State of New Mexico
Energy, Minerals and Natural Resources

SUNDRY NOTICES AND REPORTS ON WELLS (DO NOT USE THIS FORM FOR PROPOSALS TO DRILL OR TO DEEPEN OR PLUG BACK TO A DIFFERENT RESERVOIR. USE "APPLICATION FOR PERMIT" (FORM C-101) FOR SUCH PROPOSALS.)	
1. Type of Well: Oil Well ☐ Gas Well ☒ Other SWD	
2. Name of Operator Resolute Natural Resources Co., LLC	
3. Address of Operator 1675 Broadway, Ste 1950, Denver, CO 80202	
4. Well Location Unit Letter J : 1980 feet from the south line and 1650 feet from the west line Section 27 Township 14S Range 37E NMPM 6 County Lea	
11. Elevation (Show whether DR, RKB, RT, GR, etc.) 3821 GL

OTHER: change tubing

Well Name: Shell Maxwell 27 01 SWD

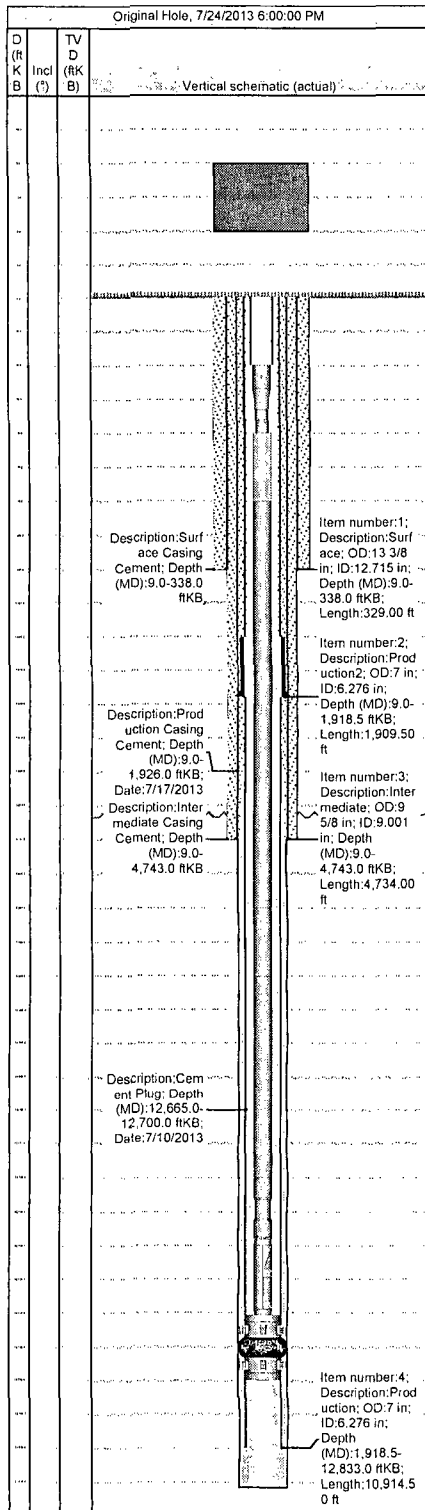
Resolute proposes to change out the 3-1/2 " injection tubing to 4-1/2" tubing as soon as possible. This tubing was temporary, as the correct tubing was not available when the casing repair work was performed in July, 2013. There will be a negative impact on production while this well is being repaired. Well bore schematic showing 3-1/2" tubing is attached.
